Evaluation of the report of Tokyo Electric Power Company regarding the leakage from the 4000-t square steel tank cluster at the Fukushima Daiichi Nuclear Power Station

28 April 2015

Nuclear Regulation Authority, Japan

Figure 2 Tank leakage (report by the Fukushima Daiichi NRA Regional Office's safety inspector)

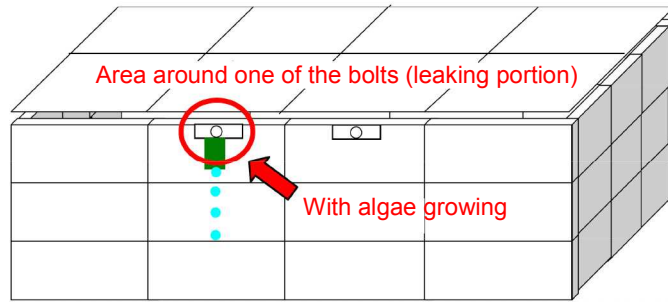
In the area concerned, water was observed to be dripping from portions around the bolts attached near the top panels of two tanks. The dripping rate was approximately one drop per second. We notified the electric utility of this event and ordered them to check the details.

Figure 4 Data on leakage outside the dike (extracted from the TEPCO report)

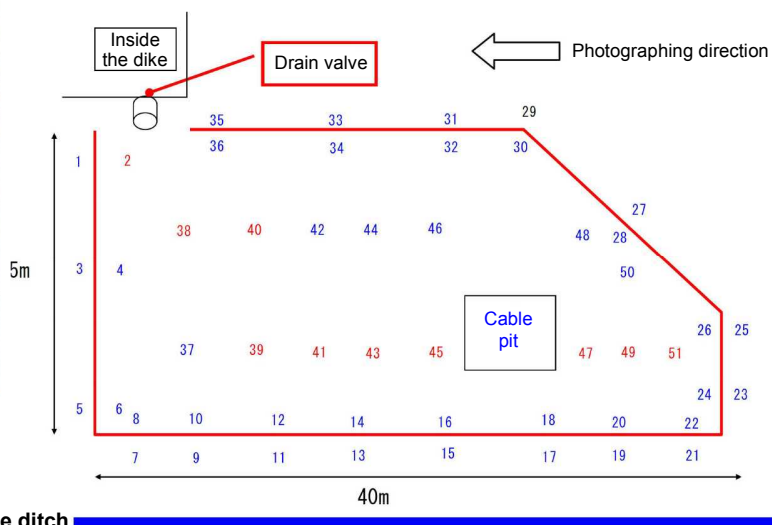
Despite the fact that the leaking water was dripping into a dike, the dike’s drain valve remained open. Tokyo Electric Power Company (hereinafter, referred to as “TEPCO”) measured the radiation dose (70 µm dose equivalent rate (β rays)) on the ground around the drain valve and outside the dike, finding a maximum radiation dose of 0.028 mSv/h within the area up to a distance of approximately 40 m from the drain valve. TEPCO therefore concluded that water in the tanks leaked outside the dike (refer to Figure 4).

- a. The drain valve, which remained open, allowed stored water that leaked into the dike to further leak outside the dike.
- b. No patrol was performed around the notch tank cluster, and thus the leakage from the portions around the bolts was not discovered.

- b. Countermeasure to ensure the dike drain valves are closed
 - All drain valves of dikes in the notch tank cluster shall remain "closed." Rules regarding this operation shall be stipulated in company manuals.

Figure 5 Formation of an opening at a notch tank top panel (extracted from the TEPCO report)

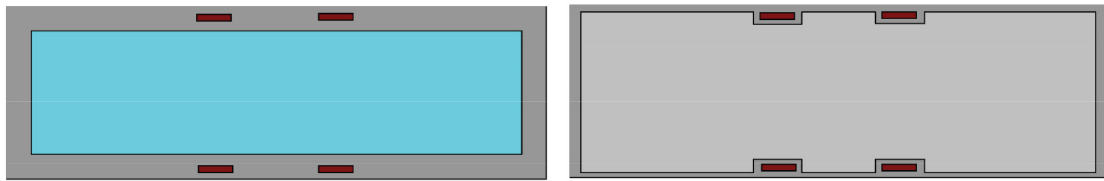
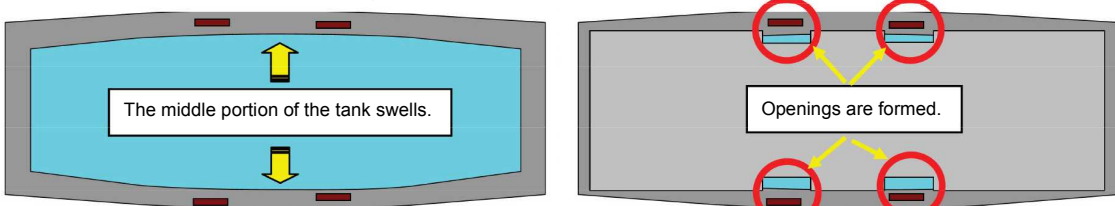
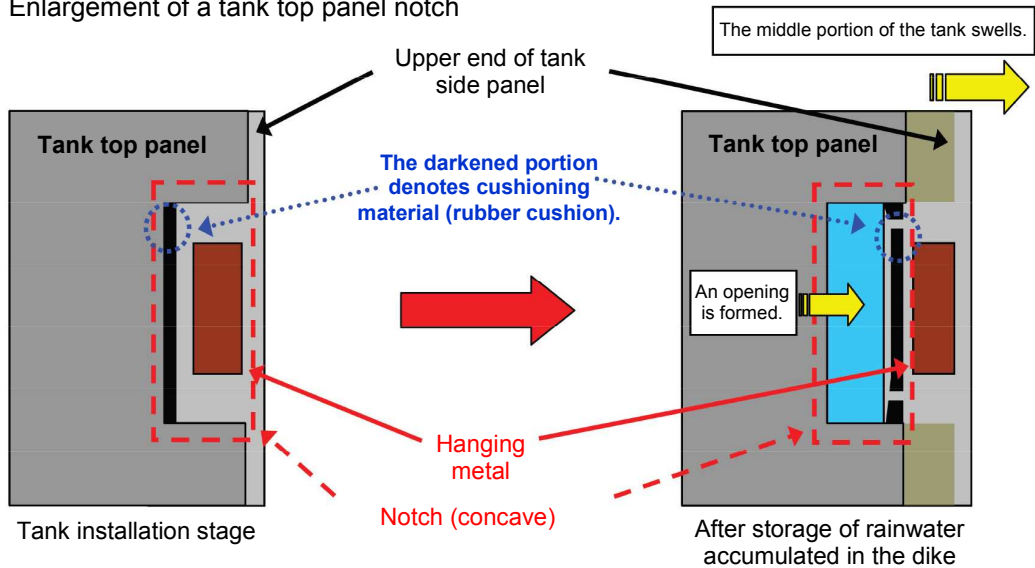
While storing water, the tanks swelled in the middle of the upper-end part of their side panels. This swelling caused gaps (openings) to develop between the tanks' top panels and hanging metal attached to the upper end of the tanks' top panels (refer to Figure 5).

Rainwater entered the tanks through these openings that had formed at the tanks' top panels, gradually leading to an increase in the water level of the 1000 t notch tank cluster. As a result, stored water leaked into the dike from the portions around the bolts, which had low cut-off performance.

- Covers shall be installed over the notch tank cluster to prevent rainwater from entering the openings along tanks' top panels and to prevent rainwater accumulation from increasing in the dike for the notch tank cluster.

- Inspections shall be carried out on the notch tank cluster once a week to confirm that tanks' water levels do not exceed the reference upper limit (approximately 20 cm below the tanks' top panels).

Figure 6 Results of drainage-ditch and ocean monitoring (extracted from the Secretariat of the NRA's document for a meeting with TEPCO)

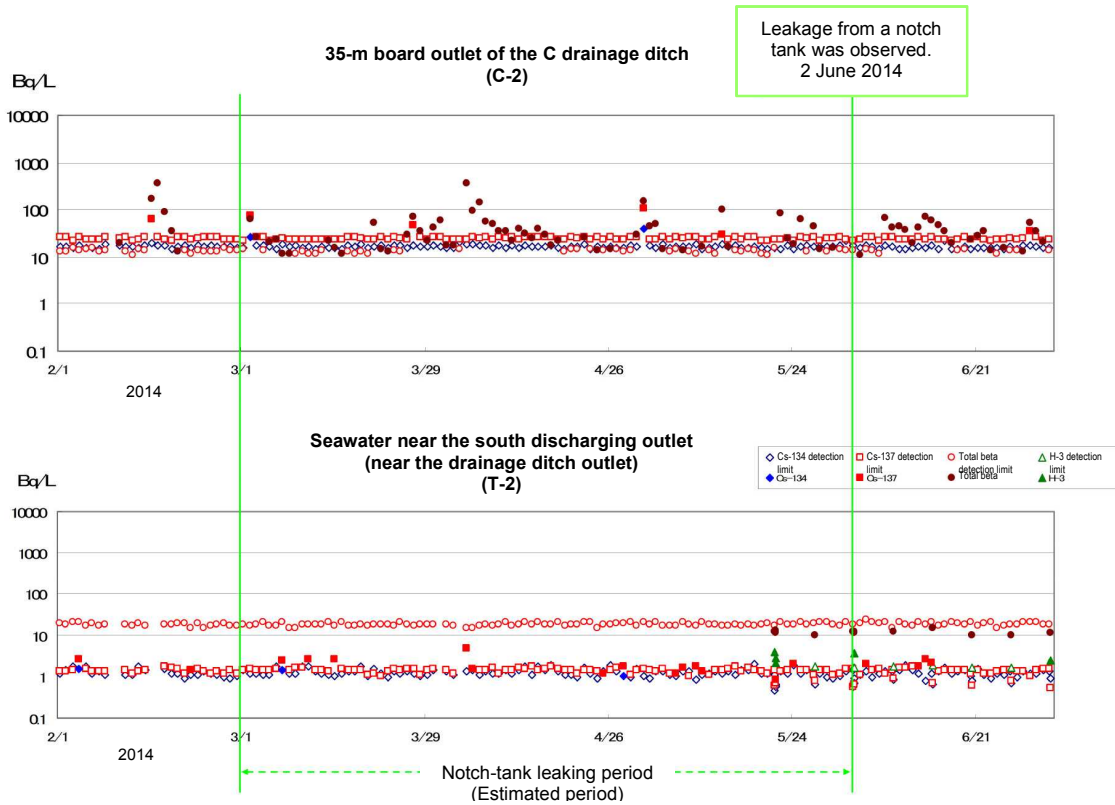
There is no obvious fluctuation in the results of monitoring before and after the leakage occurred in the vicinity of the 35 m board outlet (C-2) of the C drainage ditch and the vicinity of the south discharging outlet (T-2). The NRA therefore concludes that this event did not cause ocean contamination that raises any concerns about effects on health or the environment (refer to Figure 6).
